Report of the Strategic Director, Regeneration to the meeting of Bradford East Area Committee to be held on 14 January 2016.

AN OBJECTION TO A PROPOSED TRAFFIC REGULATION ORDER ON LEEDS ROAD NEAR SEYMOUR STREET, BRADFORD

This report considers an objection to a recently advertised Traffic Regulation Order for No Waiting At Any Time restrictions on Leeds Road, Bradford at its junction with Seymour Street.

11.1 Appendix 1 – Drawing No. TDG/THS/102732/CON-1A.

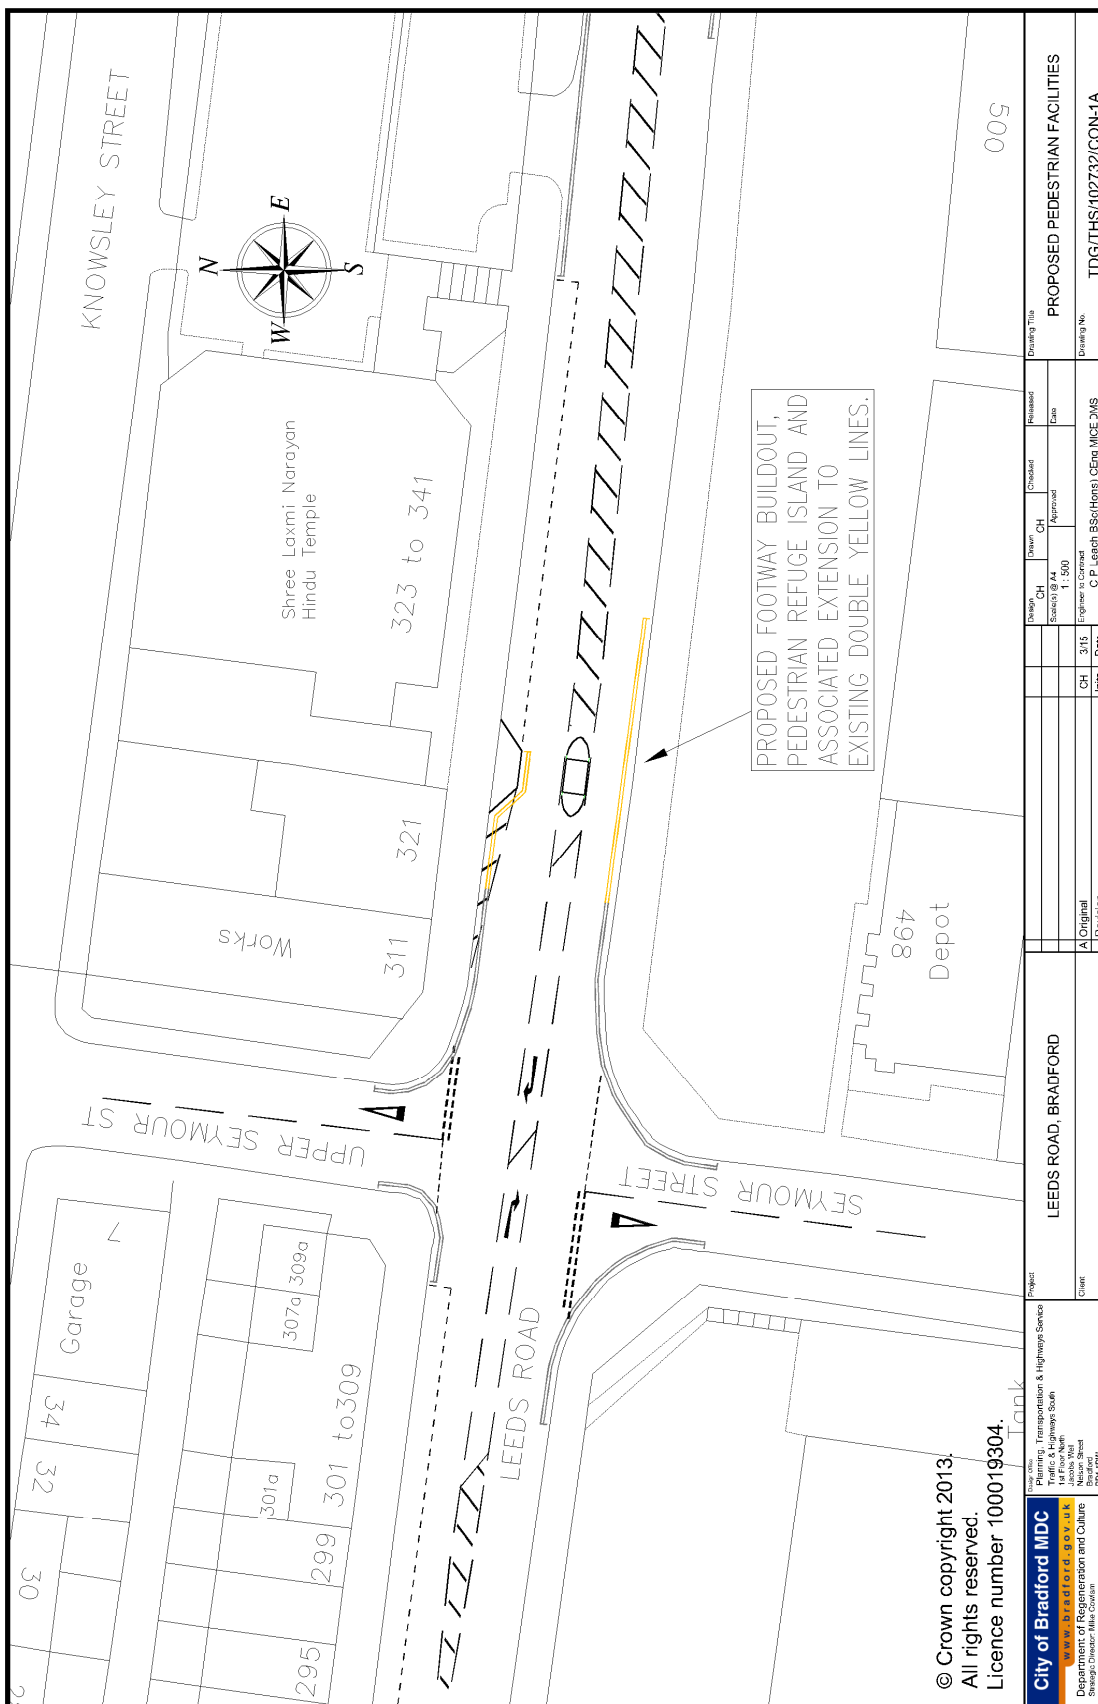
Objectors concerns	Officer comments
1. The loss of parking space on Leeds Road adjacent to properties numbered 311 and 321 which have no off street parking and which the owners would like to regenerate and bring back into use.	The double yellow lines would displace about 6 car lengths. 2 on the north side of Leeds Road and 4 on the south. The extension of the yellow lines has been minimised by the introduction of the footway buildout.

2. The Hindu Temple at 323 – 341 Leeds Road is regularly visited by people travelling by coaches who are dropped off on Leeds Road. Turning this area into a formal parking bay will prejudice this use and make it harder for coaches to drop off older and disabled people close to the main entrance.	There are no proposed waiting restrictions adjacent to the Temple. The intermittent white line will mark out an informal parking area and the carriageway running lane. This will have no effect on the current dropping off by coaches. This area will be available for use by any driver as it currently is. This white lining could be omitted.

3. They do not consider that this crossing point will be used and think that adding this feature will increase congestion on this already busy and congested road.	There are a disproportionate number of pedestrian casualties on Leeds Road and because it is busy and congested with traffic additional facilities are needed for pedestrian safety. In a snap shot 30 minute observation (14.40 – 15.10) 3 pedestrians crossed near the proposed refuge location and 38 vehicles turned right into Upper Seymour Street. The refuge island will also offer some protection for turning traffic.

10.1 That the objection is overruled and that the Traffic Regulation Order for waiting restrictions on Leeds Road, Seymour Street and Upper Seymour Street is sealed and implemented as advertised.
